STANDARDIZATION OF COMPONENTS
FOR
CD V-700, CD V-715, CD V-727

BY
THE VICTOREEN INSTRUMENT COMPANY
CLEVELAND, OHIO

III. Recommended Specification Changes

A. Changes in CD V-700 Specification dated November 1, 1959.

FIGURE 4

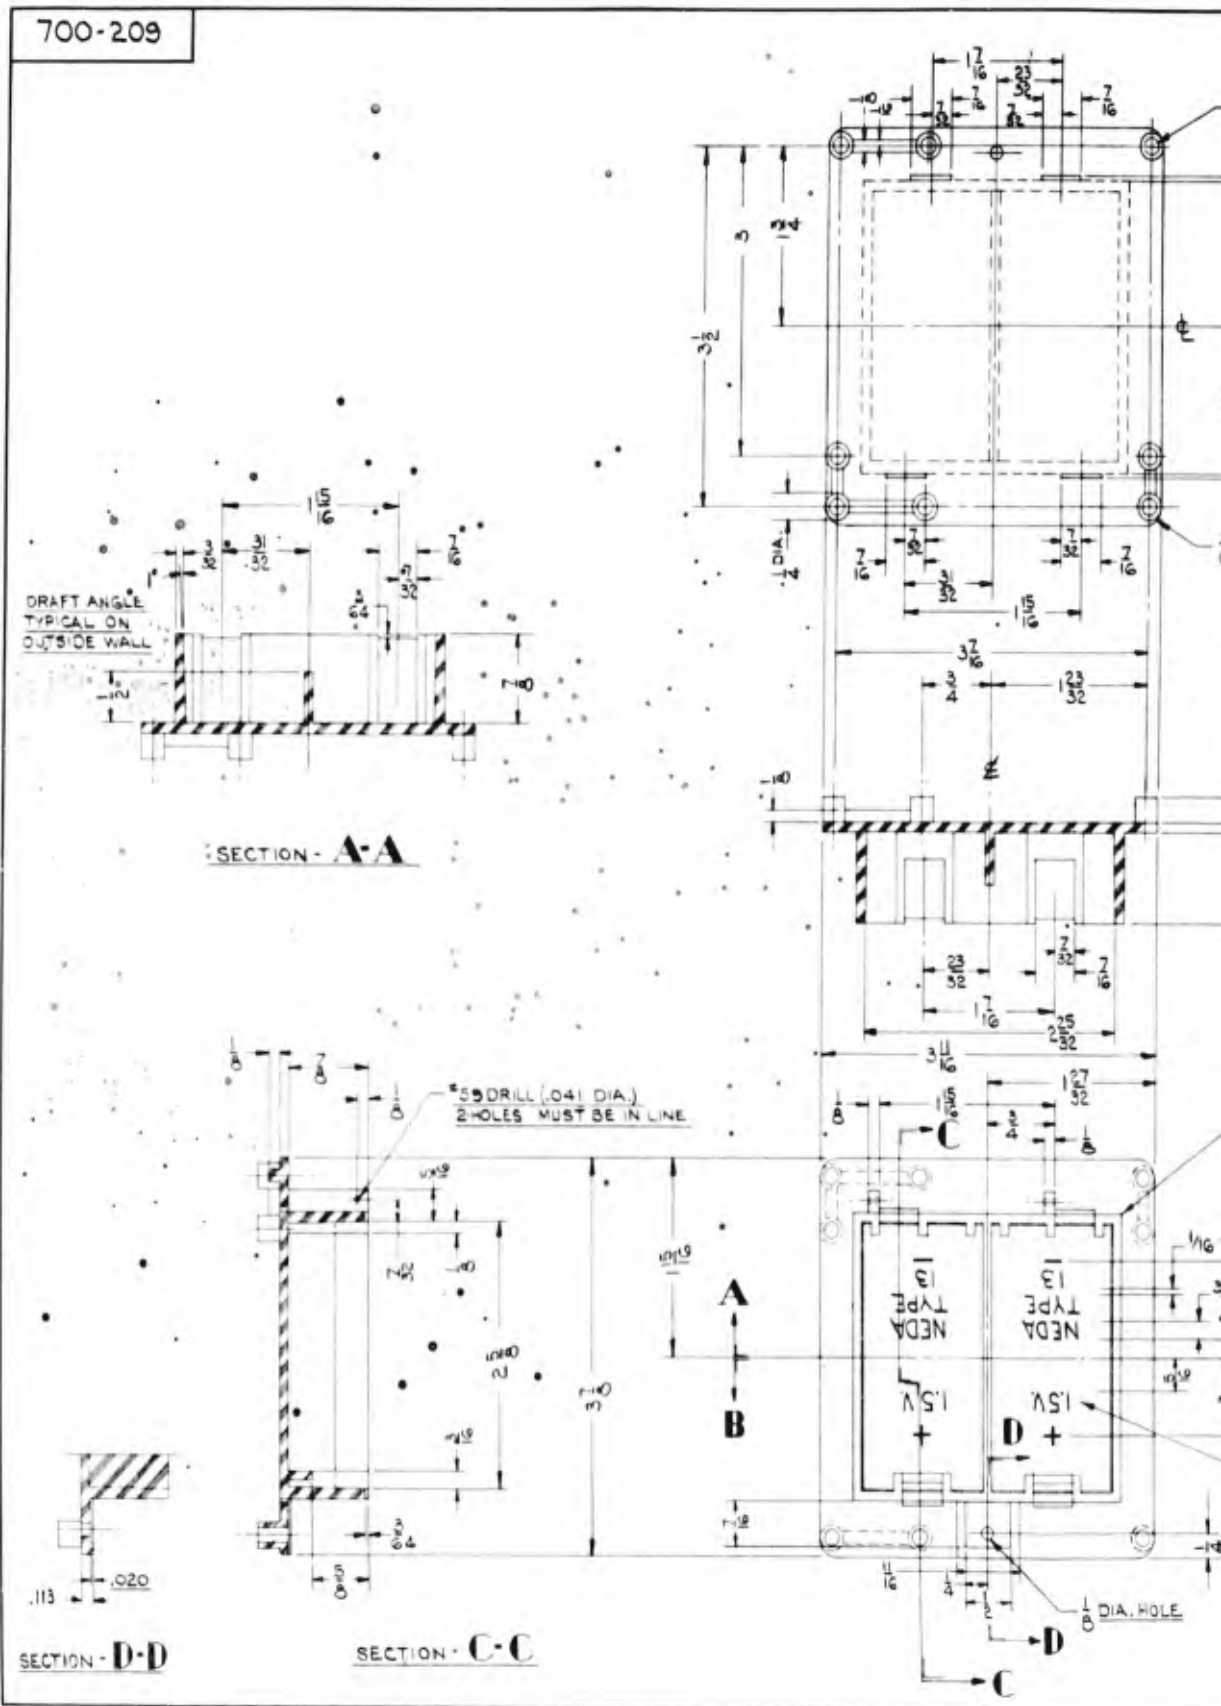
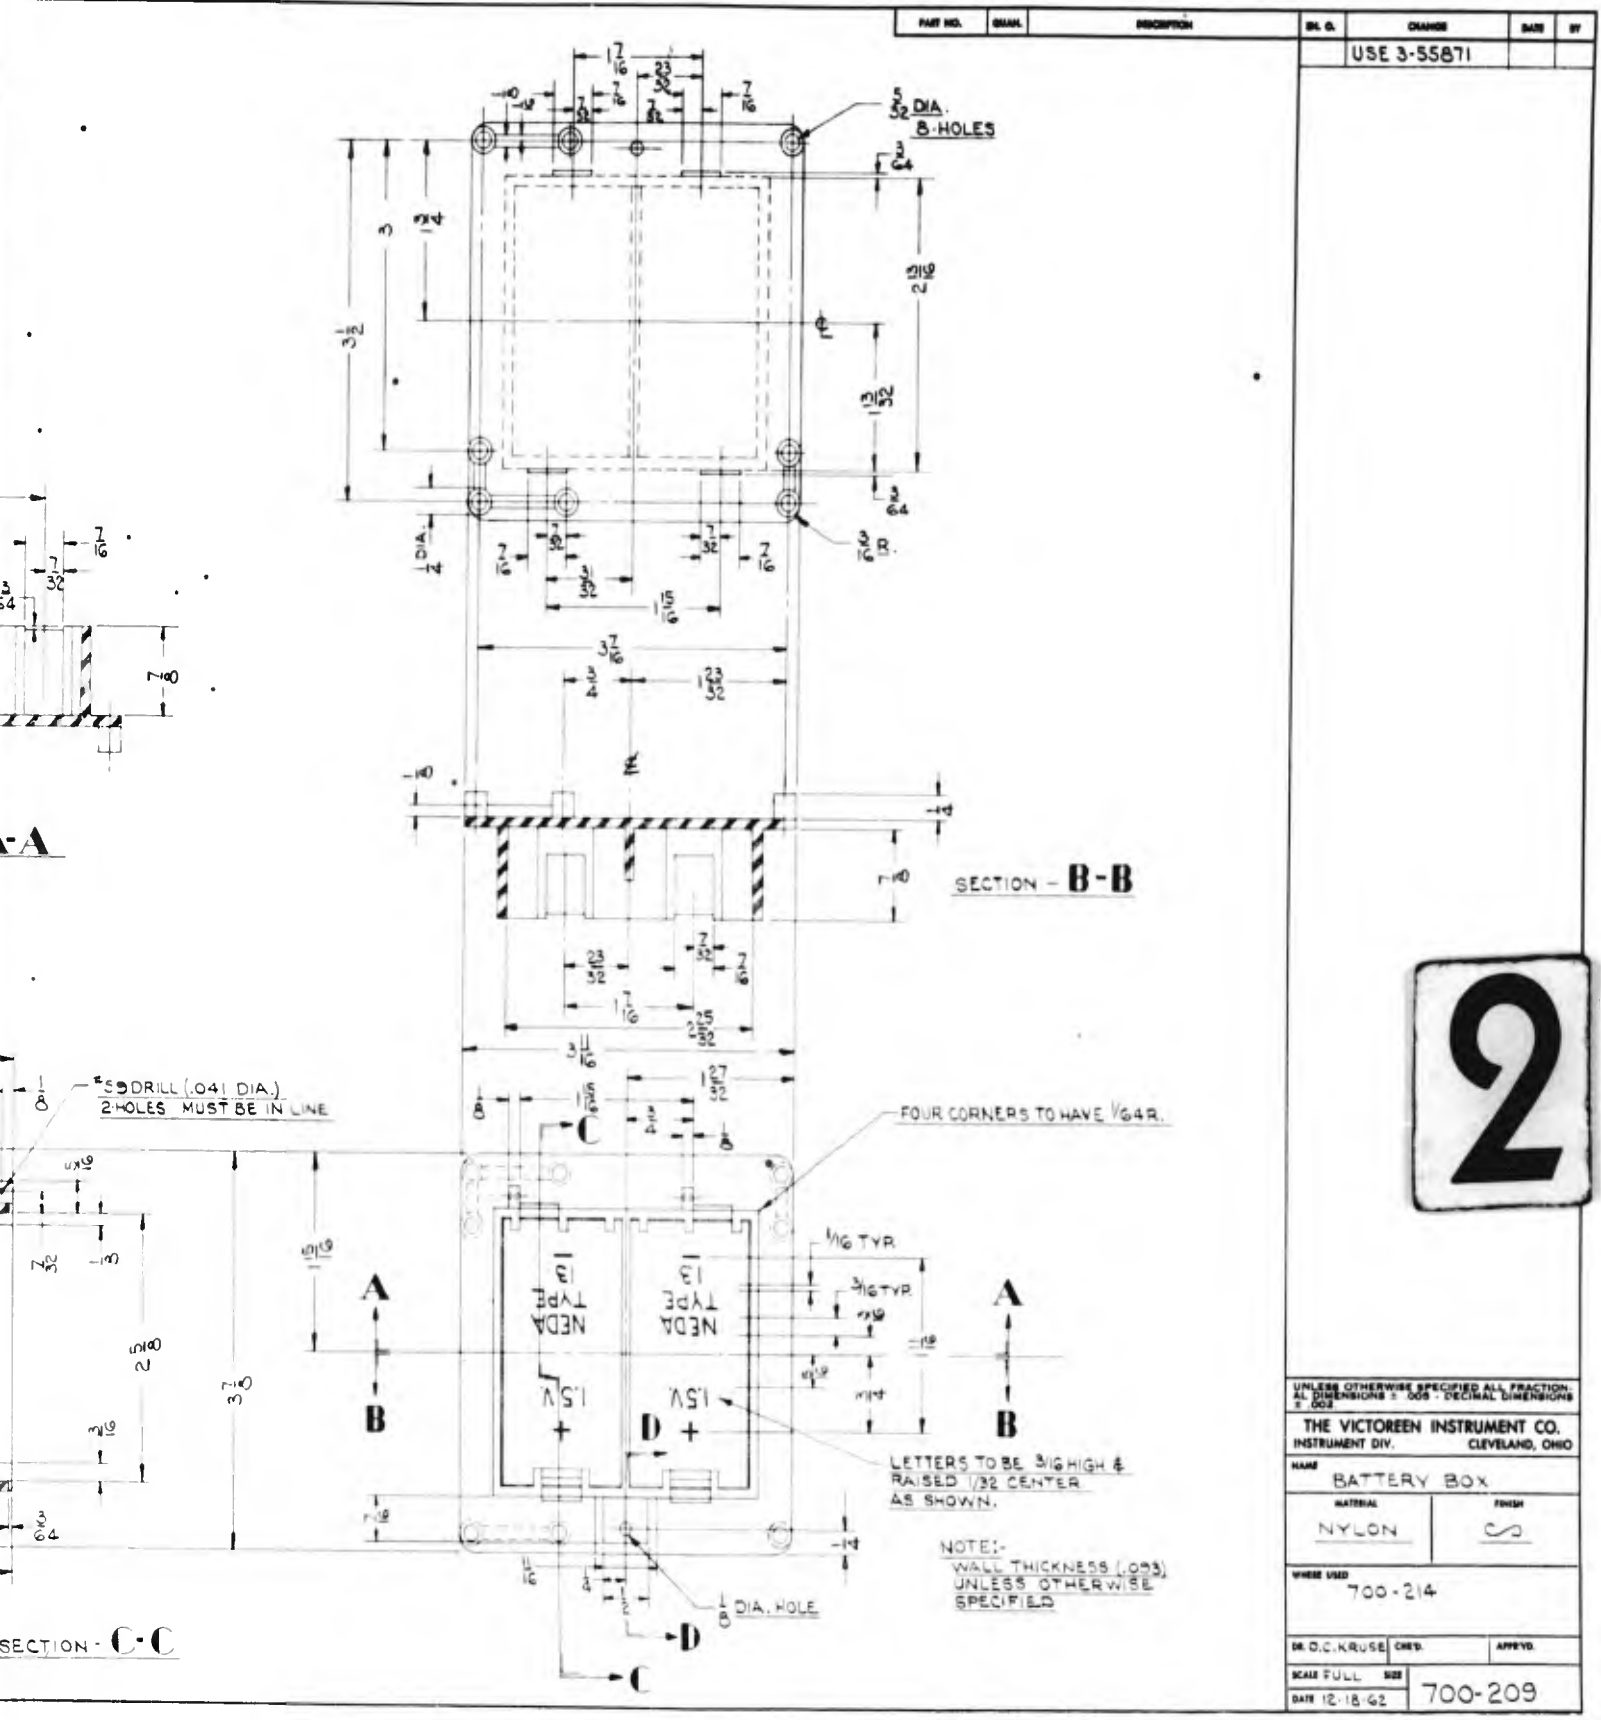
13. Attachment D. Replace page D-2 with drawing 815-103 (Figure 1 of this report). Replace page D-3 with drawing 700-214, battery box assembly, and details 700-209 and 700-210 (Figures 3, 4 and 5 of this report). Add as page D-6 the drawing 815-106, case bottom (Figure 2 of this report).

8. Attachment D-2. Replace battery box drawing with drawings 700-214, 700-209, 700-210, 815-100, 815-101, and 815-102 (Figures 3 thru 8 of this report).

FIGURE 6

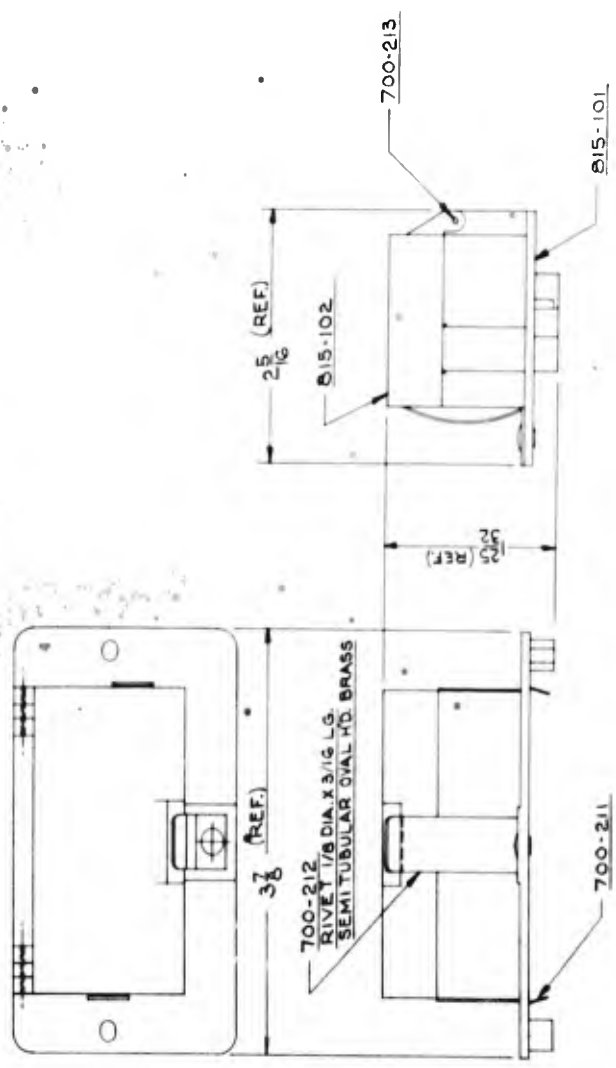
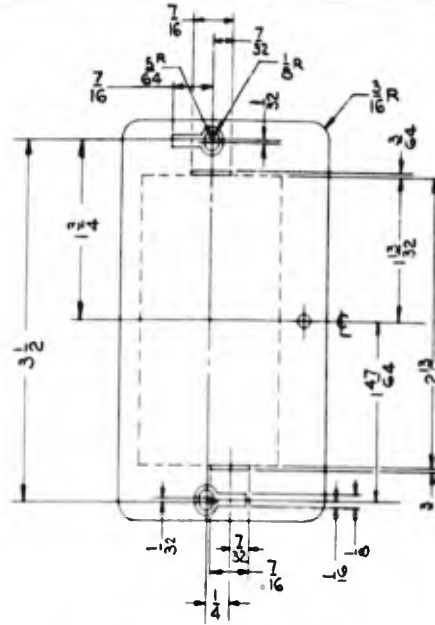
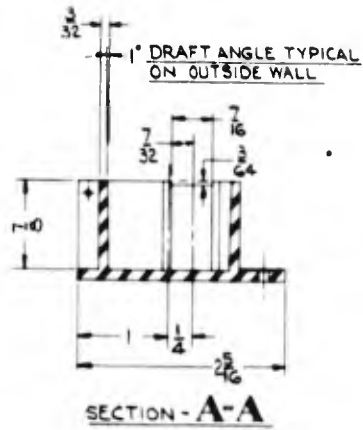
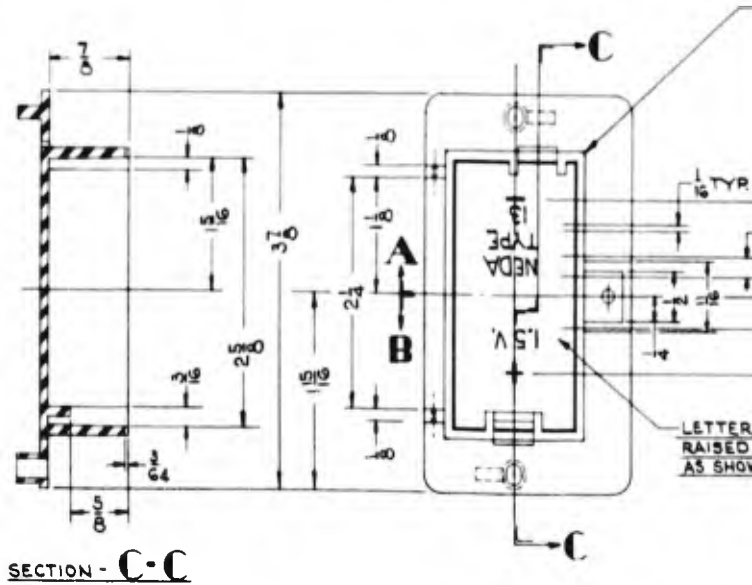
11. Attachment D. Add a new page D-2 showing drawing 815-100, battery box assembly and detail drawings 815-101 and 102 (Figures 6, 7 and 8 of this report).

FIGURE 9

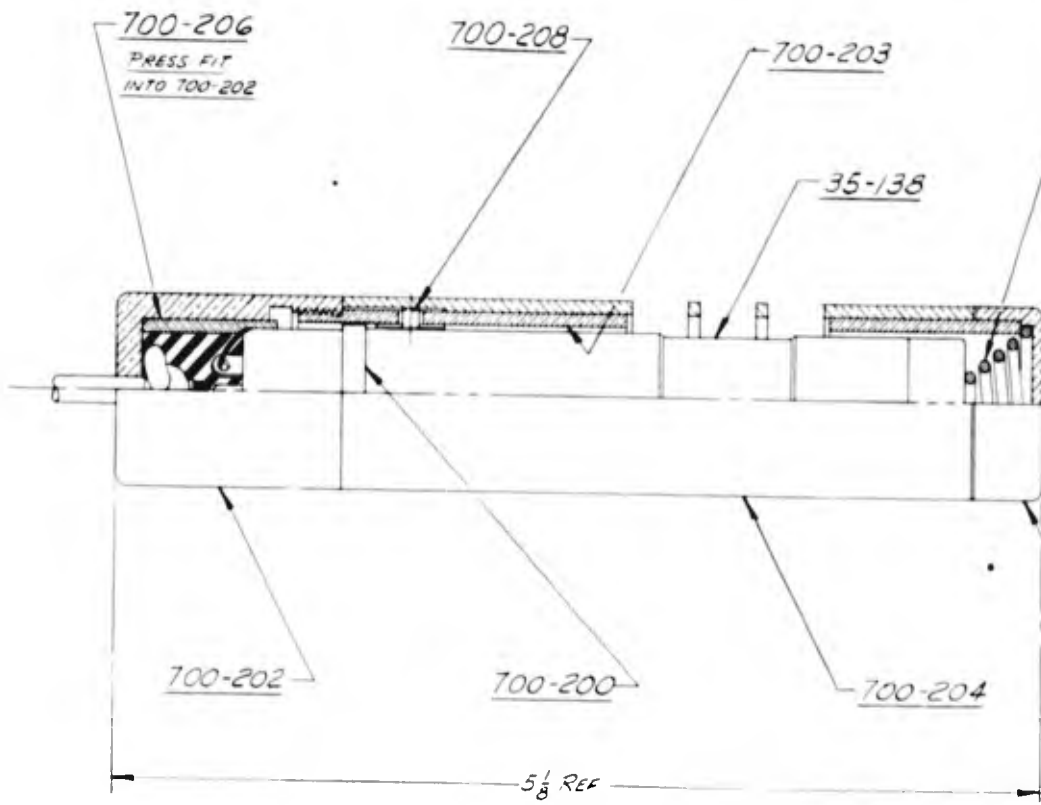
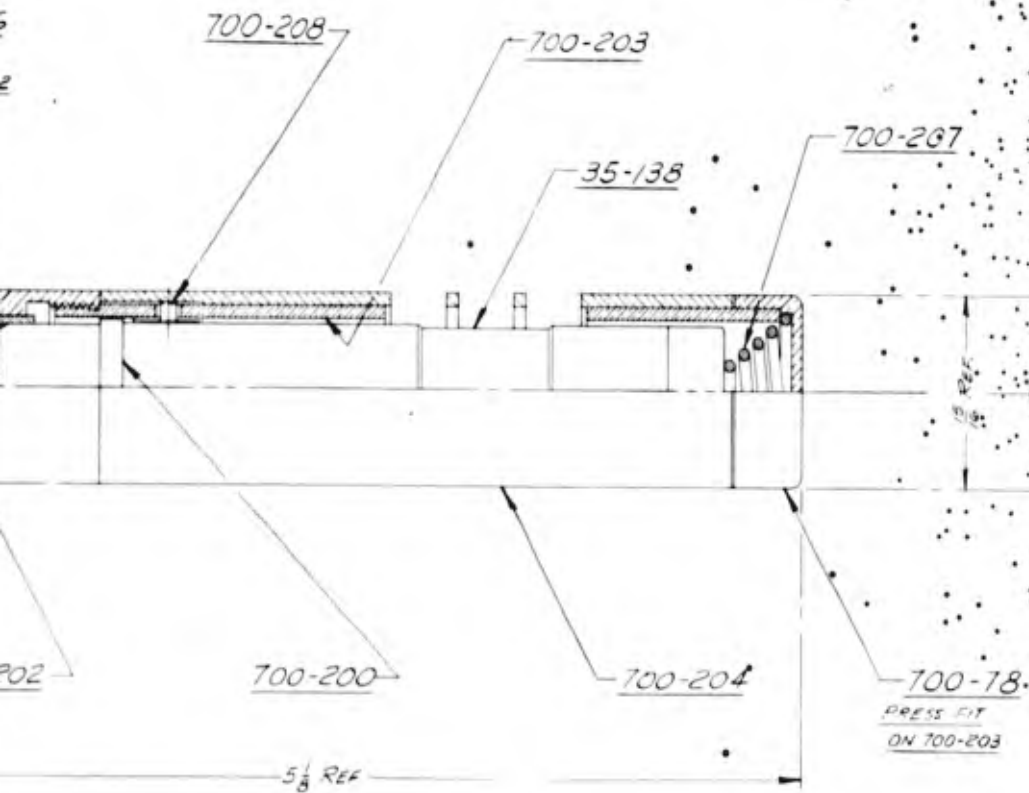
12. Attachment B. Replace drawing of page B-1 with drawing 700-205 of probe assembly and details 700-202, 700-203, 700-204 and 700-206 (Figures 9 thru 13 of this report).

The geiger tube probe drawings, Figures 9 thru 13, along with the changes of tolerance on the window location of the geiger tube makes for a uniform assembly in which the geiger tube window and the probe window will always line up properly. Figures 16 thru 21 show the complete developmental story. Figure 16 is the present specified geiger tube. Figure 17 shows the variations in window position possible. Figure 18 shows the result on the combination of probe and tube as presently specified and found in the prototypes. Figures

FIGURE 14

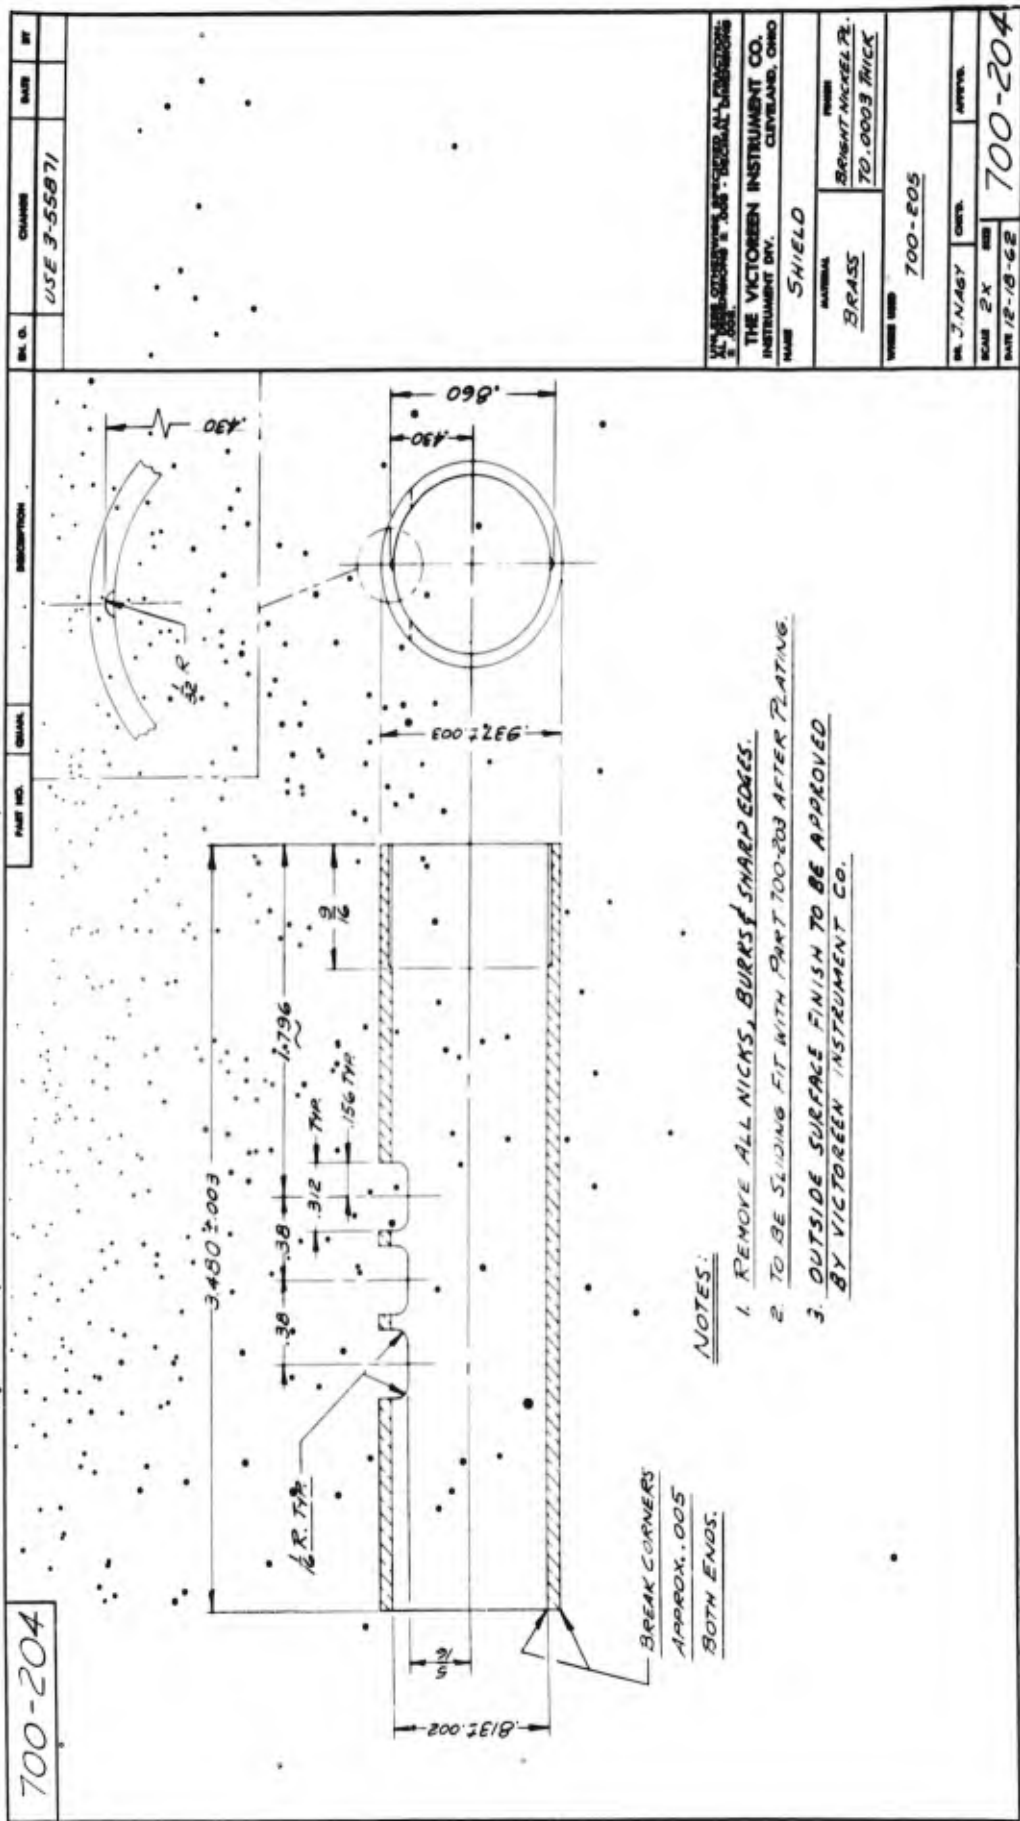
9. Attachment A. Add the drawings of the ion chamber parts submitted with the prototype instruments. As an alternate add drawing 815-12 of the feed-thru terminal (Figure 14 of this report) and a word description of the chamber parts as in the CD V-727 or CD V-717 specifications.
